**Moorabool Planning Scheme Amendment C108moor
Ballan Precinct 5**

Panel Report

10 September 2025

Figure 2 Development Concept Plan (Map 1 in DPO9)

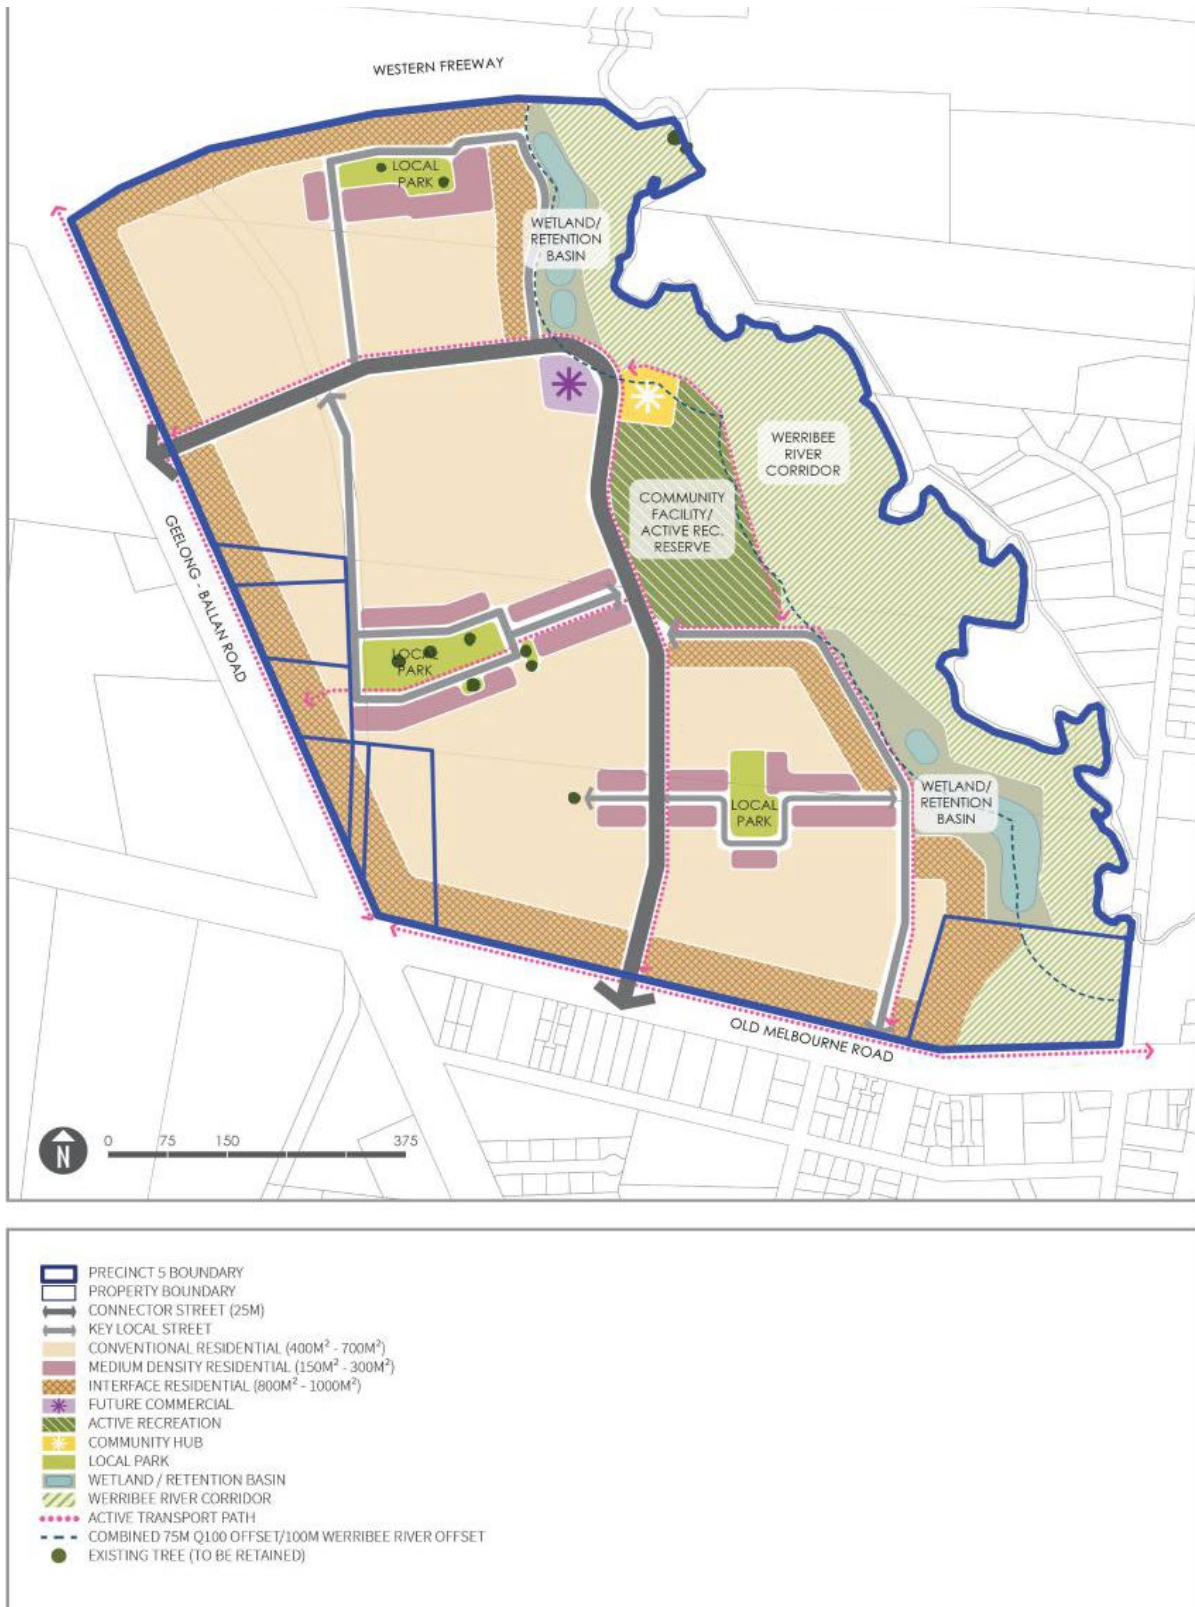
Development Concept Plan to avoid any concern that the location of the centre as shown on a future development plan is not 'generally in accordance with' the Development Concept Plan.

If the preferred location remains as exhibited, the Development Concept Plan could be amended to designate a small amount of medium density housing around the centre, although this would potentially intensify development closer to the Werribee River corridor (discussed in more detail in Chapter 4).

- It supports the inclusion of a small local commercial centre on the Development Concept Plan.
- It sees merit in both the location shown on the exhibited Development Concept and the alternative location (further south) suggested by Mr Barnes.
- Council and the Proponent should further consider which is the preferable location and amend the Development Concept Plan (if required) before the Amendment is adopted.
- Locating medium density housing around the local commercial centre is supported in either location.

Figure 4 Mapping correction to the extent of Habitat Zone Patch A

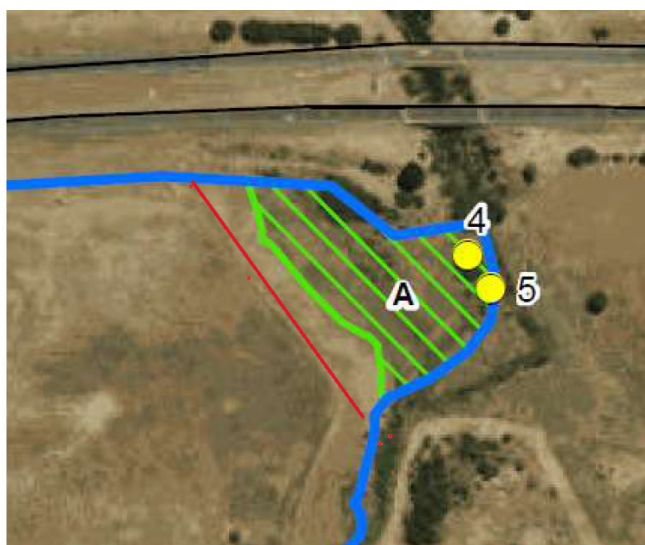
- it had missed six native vegetation patches (five of which were located in the disused aqueduct), one scattered tree
- another scattered tree required reclassification
- the assessment missed some species including the EPBC-listed Matted Flax-lily, evidence of which he found along the aqueduct.

Mr Mueck recalculated the offset requirement and confirmed General Habitat Units would be required. He considered the mapping of Habitat Zone Patch A near the river corridor in the north east part of the subject land should be extended to the red line shown in Figure 4.

Amend the Vegetation Protection Overlay Schedule 2 mapping to reflect the full extent of the patch of native vegetation known as Habitat Zone Patch A, as shown in Figure 4 in this report.
